HUMBOLDT STATE UNIVERSITY

SUBJECT: IFB #PW21-3, Sunset Roof Replacement, Project #XHS237

Addendum #2

2. Exhibit I, Sunset Roof Conformed Drawings, Drawing AS2.2

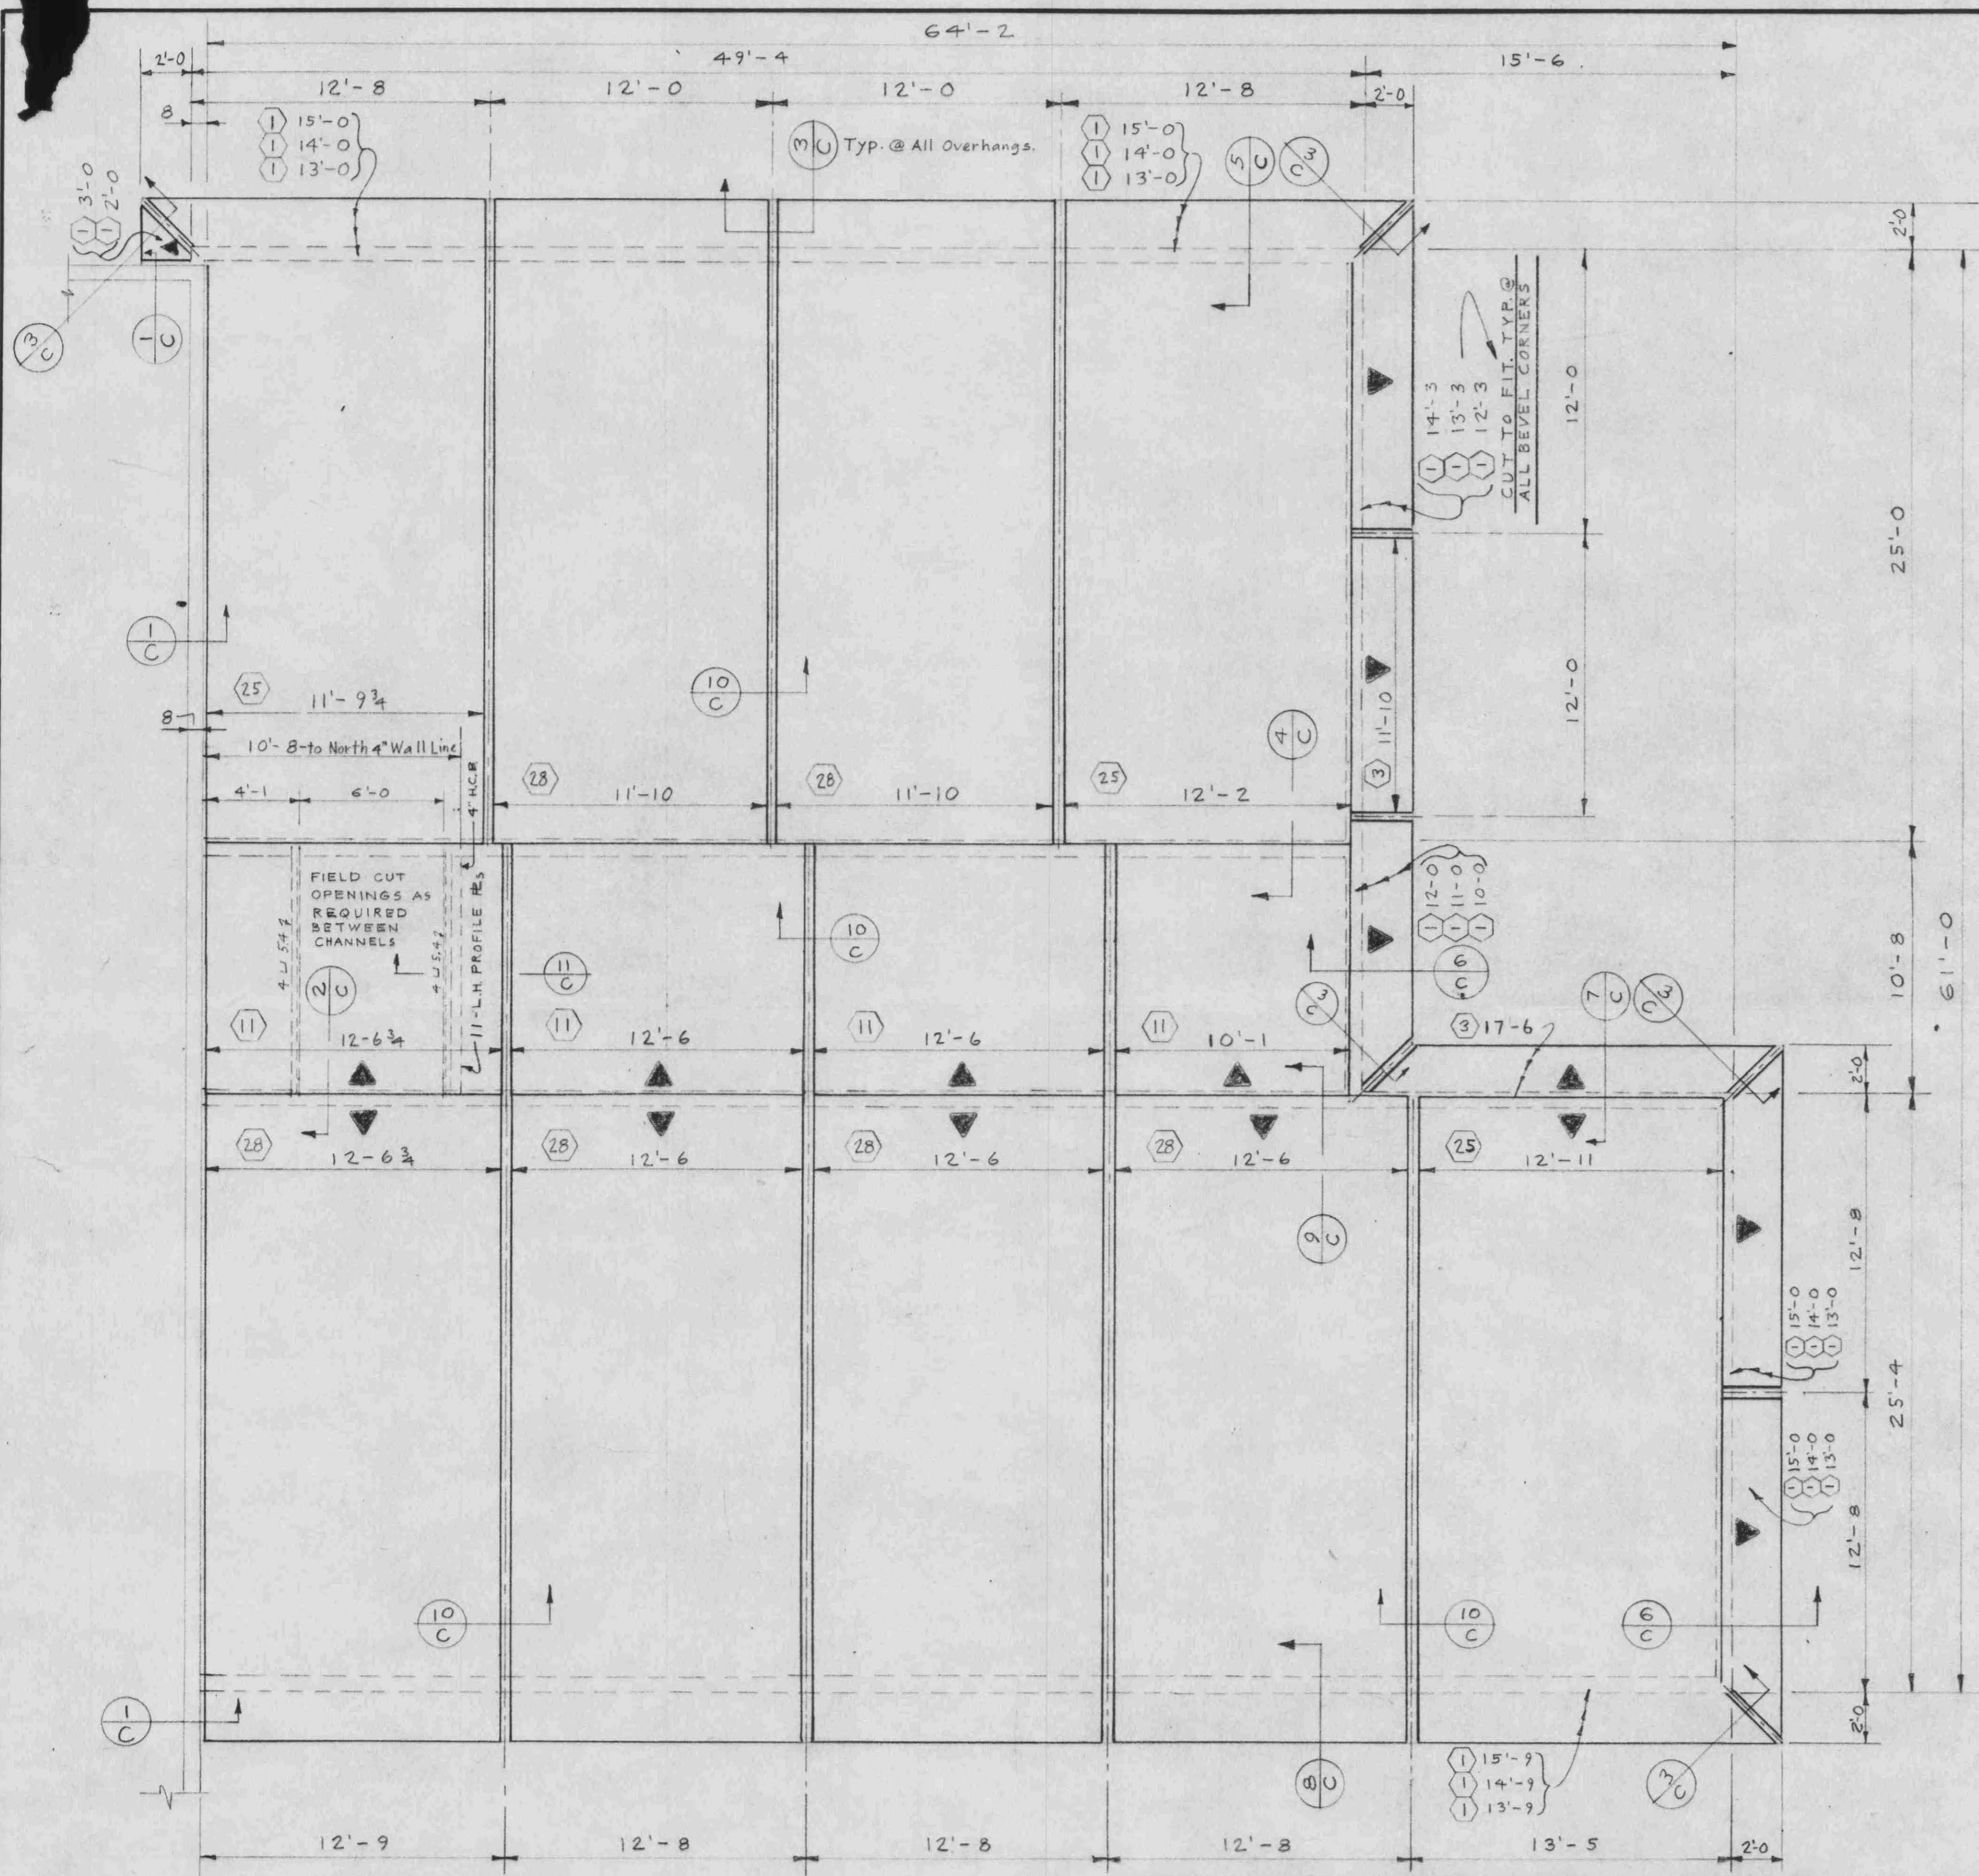
Question: Drawing AS2.2 shows a steel decking on the lower roof. What are the specifications of the steel decking (type, width and gauge). Is there partial concrete decking?

Answer: Please see the attached print sheet.
